No. HDCM14-063R4-TN

Technical News

Subject: How to fix and improve Power Supply Unit broken by Abnormal Cable or sequentially pressed CAM PW Button

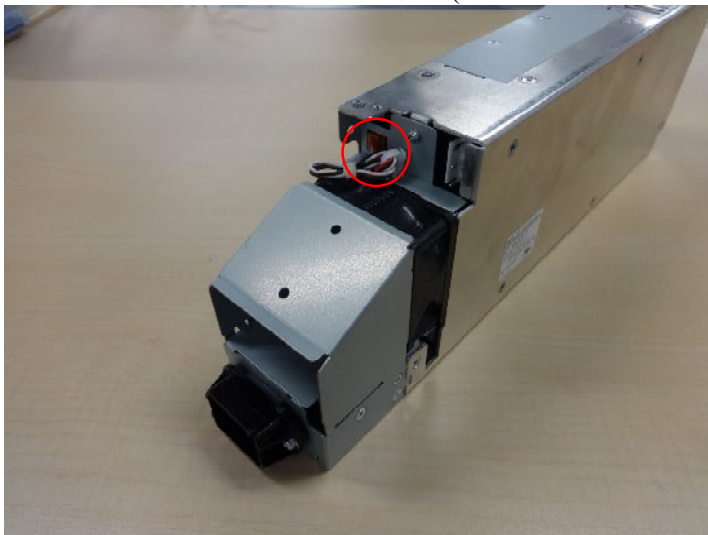
The improved parts are as follows. (Rev.4)

Part No.	Part Name
A-1768-442- B C	POWER BLOCK ASSY(D00)
A-1769-657- B C	PS-778D00 MOUNT
A-1771-369- B C	RE-274 COMPL

6. Replacement of FET

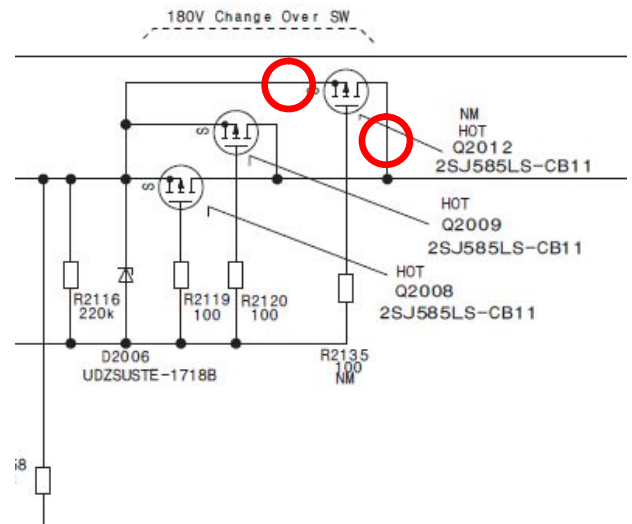
Measure the resistance between the source and the drain of the Q2012 on PS-778 board by the circuit tester.

In case of the normal board, it is about 200k Ω . In case it is almost short circuit, Q2008 or Q2009 is broken by shorting, replace them with the ones in the table below. It is not possible to specify either part is broken. The circuit is still short even after one FET is replaced, replace the other FET also.

Part No.	Part Name	Qty	Ref
8-729-054-30	TRANSISTOR 2SJ585LS-CB11	1 or 2	Q2008, Q2009 (either one, or both)
